ADDENDUM 3 REVISED: 8/20/07
REVISED: 2/19/07
REVISED: 1/24/07

4TH FLOOR PLUMBING PLAN
ST. TAMMANY PARISH ADMIN. COMPLEX
520 OLD SPANISH TRAIL
SLIDELL, LOUISIANA

RENOVATE OFFICE BUILDING
DAMMON ENGINEERING, INC.
1095 FLORIDA AVENUE 985-649-5832 SLIDELL, LA. 70458
DAMMONENGINEERING.COM

P-4

FOURTH FLOOR PLUMBING PLAN
SCALE: 1/8" = 1'-0"

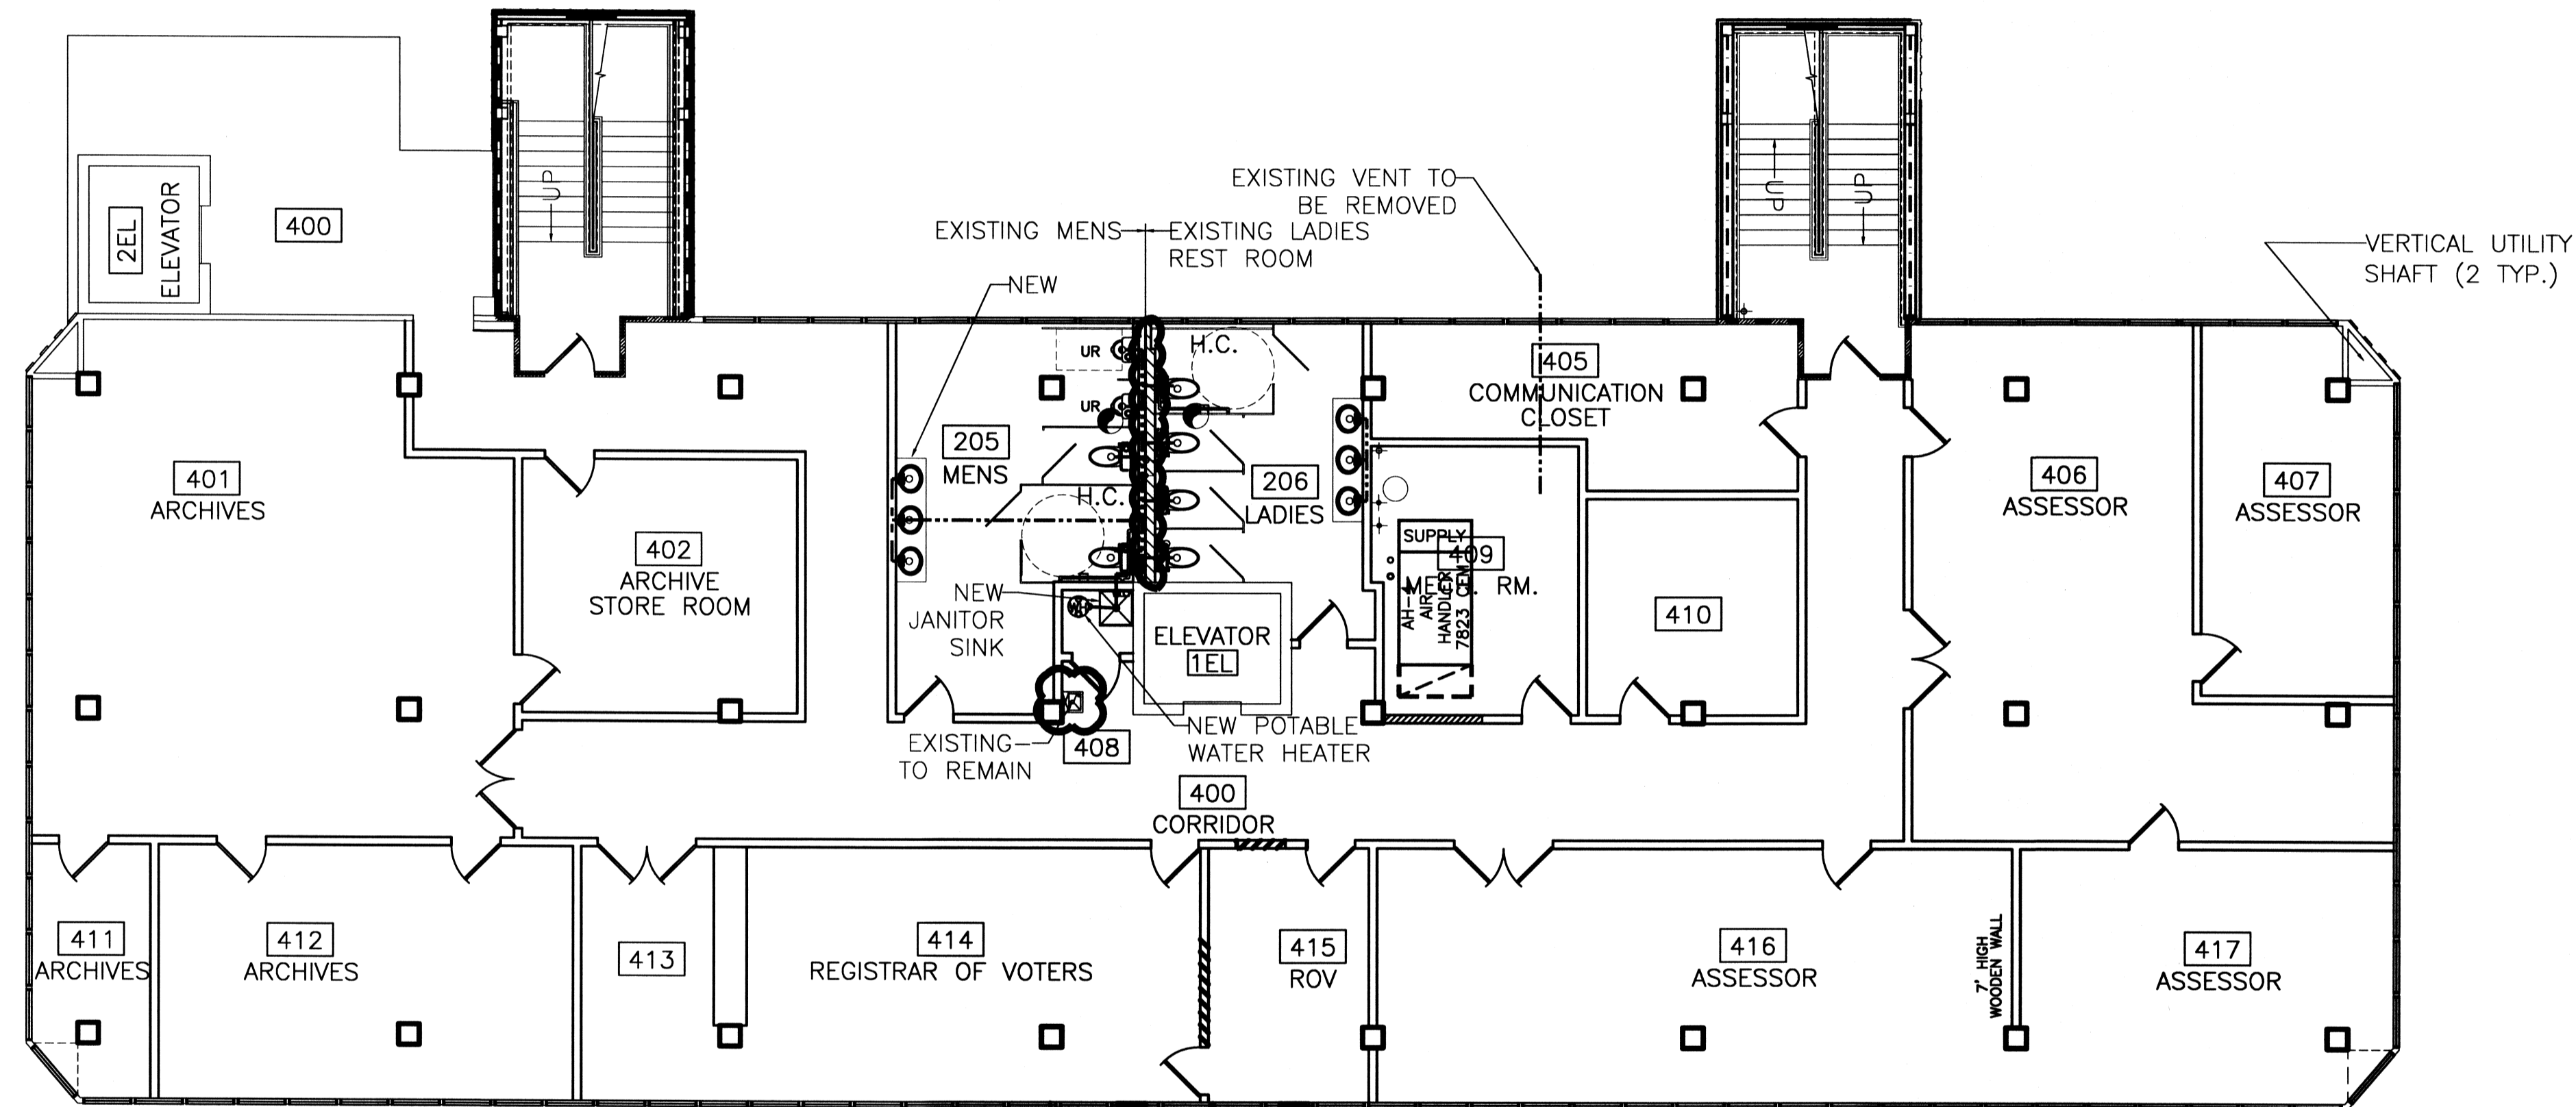
☁ = ADDENDUM 3 CHANGE
